Mecklenburg County
Health Department

Re: Sunset Circle
File: 2205B
Parcel: 037-071-37

SOIL/SITE EVALUATION
for ON-SITE WASTEWATER SYSTEM

220 S B

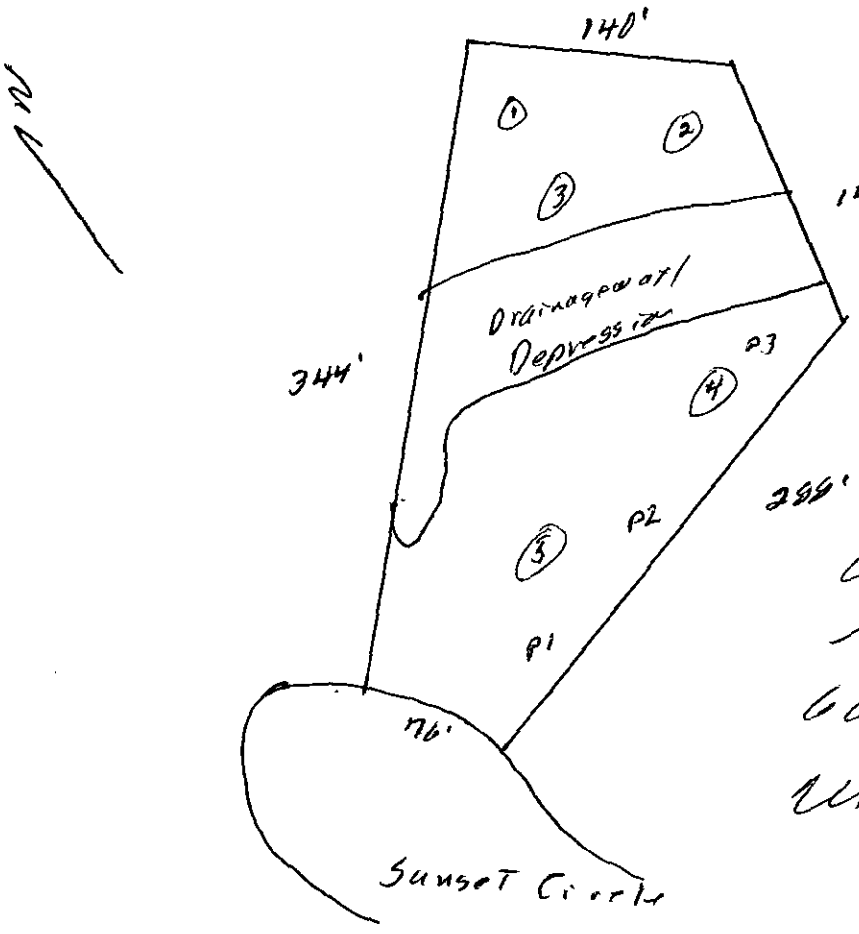
saprolite encountered in all 3 pits ranged from 2 4- 26" deep from the surface, sandy clay loam textures Chroma 2 soil colors to approx 24", to 60" in Pit 3. Saprolite unsuitable.
